FOSTER CITY LEVEE PROTECTION PLANNING AND IMPROVEMENTS PROJECT

Response to Comments Document

Capital Improvement Project No. 301-657
State Clearinghouse No. 2016012012

March 2017

FIGURE 2 EXISTING LEEVE ELEVATION DEFICIENCIES FOR WAVE RUNUP

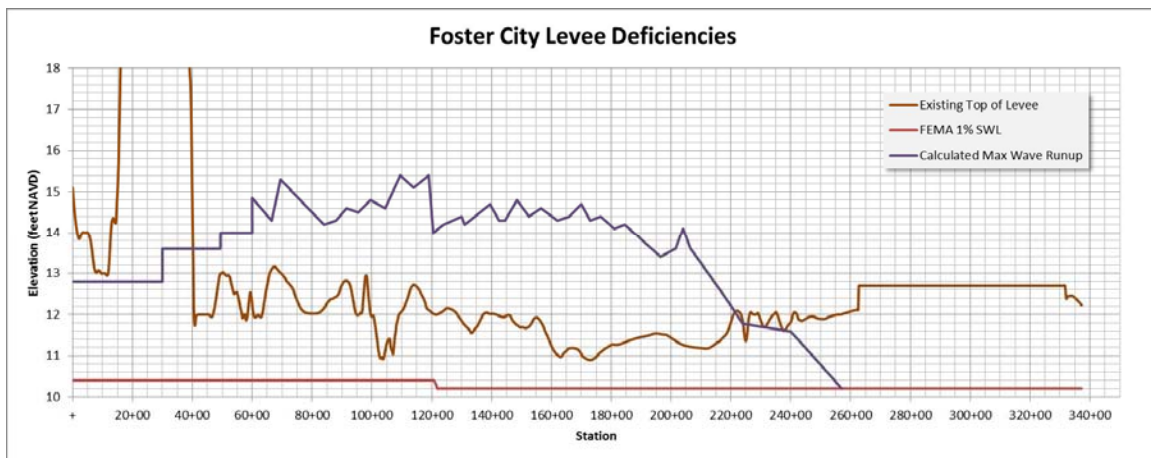
Response A1-2. The comment requests that the City develop a project alternative that maximizes the application of coarse shoreforms such as beaches, shell ridges, and similar features bayward of the existing shoreline, and revise the Draft EIR to reflect the analysis of this alternative.

As shown in Figures III-5 through III-8 of the Draft EIR, the Foster City project improvements are located on top of the City’s existing levees. That is, there is no encroachment into San Francisco Bay, defined as the outboard top of levee. As shown in profile (see Figure 2), at no location along the project alignment are high tide elevations associated with the one-percent storm surge anticipated to overtop the existing protective levee. Thus bay tides cannot physically be impeded or redirected by the project. Rather, the levee has inadequate freeboard for FEMA accreditation, both for stillwater surge in some locations and more particularly, for the controlling wave runoff. (Existing top of levee elevations shown in Figure 2 are based on a detailed topographic survey conducted in 2016.)

There is a 2.5-mile stretch of the existing levee system that is subject to overtopping, spanning from the high ground at Mariner’s Point on the west end to the shell bench on the east end near the mouth of Belmont Slough (Figure 2). This 2.5-mile stretch is broken into 10 sections, each with a similar average levee slope, and the break parameters and overtopping rates (in cubic feet per foot) are estimated for each section. Two methodologies have been chosen to estimate the mean rate of wave overtopping. The first, formulated by Owen (1980) and updated in the EurOtop overtopping manual, uses empirically derived coefficients for various structure slopes:

FIGURE 5 OFFSHORE WIND EFFECT ON WAVE SETUP

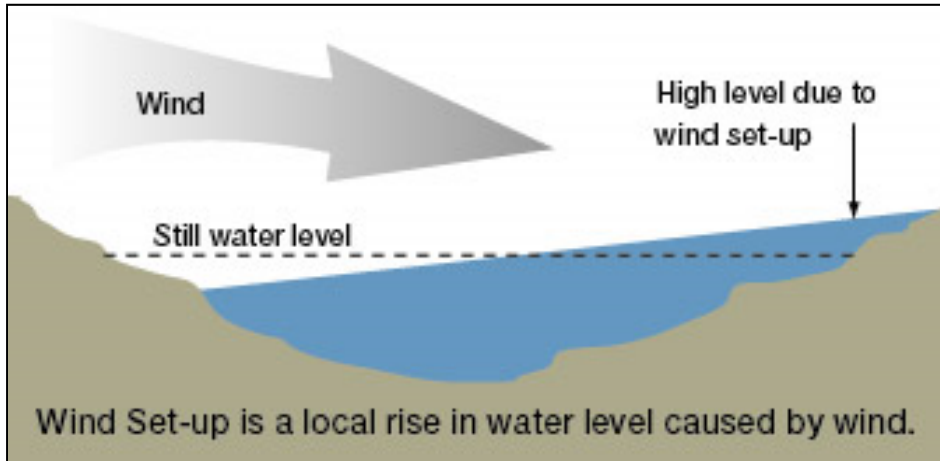
This comment also states that recent research by Professor Mark Stacey at UC Berkeley indicates that shoreline hardening in the South Bay may exacerbate tidal flooding elsewhere in the bay, often referred to as the “bathtub effect.” The project design team has been in contact with Dr. Stacey at UC Berkeley to discuss his research on the bay and its applicability to the project. Dr. Stacey clarified that he refers to “shoreline hardening” as preventing the bay from encroaching into an area currently subject to tidal flooding. He does not consider improvements to already hardened or armored shorelines, such as the Foster City levee, to be “shoreline hardening” because these shorelines are already protected against encroachment from tidal flooding. Because the existing Foster City levee does not experience overtopping during a 100-year tide event, Foster City is not currently subject to

It is also noted that prevailing winds would also act to render insignificant the impact of increasing freeboard at the Foster City levee system. Generally wave overtopping at Foster City would only occur when waves are directed towards the City’s levees with a prevailing southwesterly wind. This condition would generally result in wind-induced setup, or a local rise in water surface downwind and an associated drop in water surface upwind; that is on the levee side of the bay, and in this case specifically, Alameda County. Conversely Alameda County should be more concerned about the impact of wind-driven waves when the prevailing wind is in the northeasterly direction, generally perpendicular to its shores; when at Foster City this prevailing wind is offshore and levee improvements to protect against wave runup are not in play. Figure 5 illustrates this effect.

As demonstrated above in Figure 5, the project would have only a negligible impact on water levels around the bay, far less than the 0.1-foot water level increase suggested by

FIGURE 8 "BAYSIDE LEVEE" RENDERING PREVIOUSLY PROVIDED BY LAW OFFICES OF MARK C. WATSON

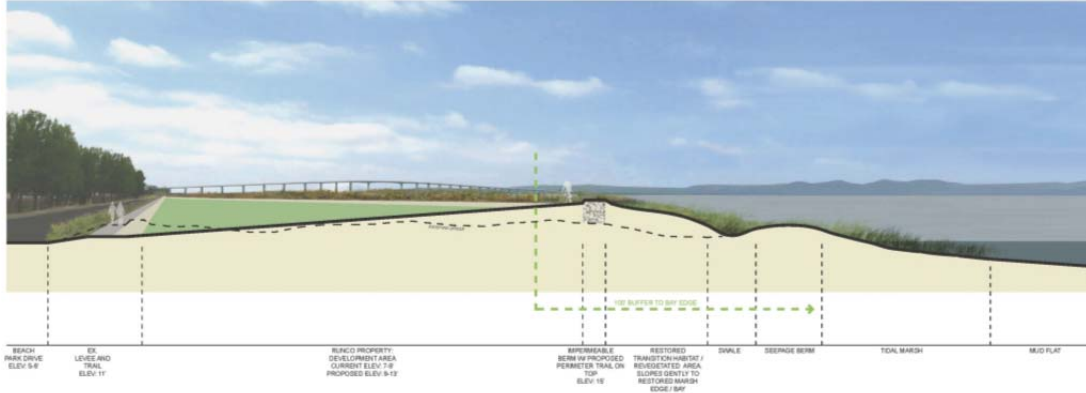
Response B1-9. The comment refers to mock-up renderings submitted by the Offices of Mark C. Watson, referred to as the "Bayside Levee" suggested by the commenter and included as Figure 8. These renderings appear similar to the levee realignment Mr. Runco

The alternative advocated by the commenter is not to be confused with a “horizontal levee” with hundreds of feet of offshore fill. A true horizontal levee that would effectively dissipate wave energy needs to typically be laid back with 30:1 side slopes as measured horizontal to vertical. Such a levee configuration could extend a significant distance into San Francisco Bay at the location shown on conceptual plans (shown in Figure 8) for this requested alternative. The alternative suggested by the commenter is rather a relatively traditional levee system, but with restored habitat on the offshore slope. Since an offshore breakwater is not shown, the levee elevation still needs to be sufficiently high to provide the requisite FEMA freeboard against wave overtopping.

The alignment of the “Impermeable Berm with Proposed Perimeter Trail” is not sufficiently precise to allow for a meaningful impact analysis. Figure 8 shows the location of the berm as apparently 100 feet away from the “bay edge,” with that edge defined as “tidal marsh,” but that edge is not defined in terms of tidal elevation. The requisite elevation of the “Bayside Levee” alignment would, therefore, need to be verified to determine its viability for wave protection since it is much closer to the shoreline than the existing levee alignment, which has been evaluated by the City in terms of required wave protection elevations.

Note however, that the City’s conclusion that the Bayside Levee alternative is not a feasible project alternative under CEQA, does not preclude the Bayside Levee alternative from being incorporated into or approved as part of Mr. Runco’s separate development project application which will require its own separate environmental review under CEQA and will have its own project objectives.

Figure 9. Model for 100-year Wave Overtopping of Existing Levees

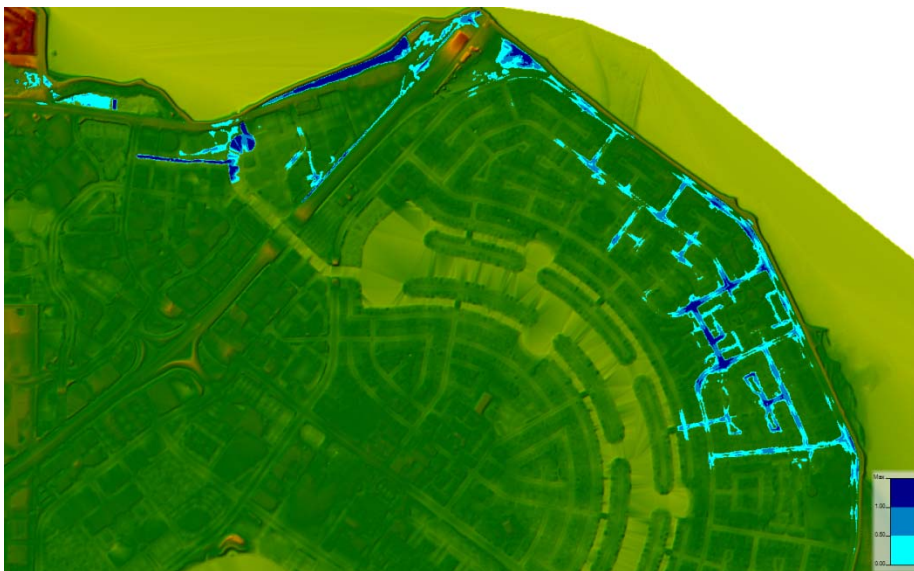
However, as noted on page 54 of the Draft EIR, Foster City (with the exception of the Central Lagoon) is currently located in Zone X with moderate-to-low risk of flooding from a 100-year flood. The comment is addressed below, relative to the existing condition. The profile in Figure 2 in response A1-2 shows the existing top of levee based on a detailed topographic

Figure 9 shows the results of a two-dimensional flow model that routes this volume of water from the perimeter levee system into the Central Lagoon; again, assuming that none of the levee system fails due to this overtopping. Although the levees are not designed with erosion protection for such overflow, it is noted that maximum overflow velocity is on the order of 2 to 3 feet per second, and while not acceptable for FEMA accreditation, it is relatively likely that the majority of the levee system would remain intact.

Figure 9 shows that bay waters are able to flow into the storm drain system and lagoon without excessively deep water spread over private properties. At its normal winter operating “storm level” of 1.0 foot NAVD, the surface area of the lagoon is 230 acres. The 23.3 acre-feet of water overtopping the levees would add about 1.0 foot of water to the lagoon. Without any pumping, the increase in water level would match the lagoon’s normal summer level of 2.0 foot NAVD. Thus the City’s existing facilities can accommodate the 100-year spill event under existing conditions, even without warning or prior evacuation of the lagoon; and there is no need to raise the pumping facility or equipment therein. Raising the levee as part of the project would greatly reduce the risk of wave overtopping and bay overflow into Foster City as shown in Figure 9, particularly since additional freeboard is provided relative to existing conditions. Since there would be no change to lagoon operations and the pumping facility is already protected against flooding, the pumps do not need to be raised in the future. Possible future sea level rise could result in higher levels in the bay that must be pumped against, but this can be adapted to by increasing individual pump horsepower within the existing facility.
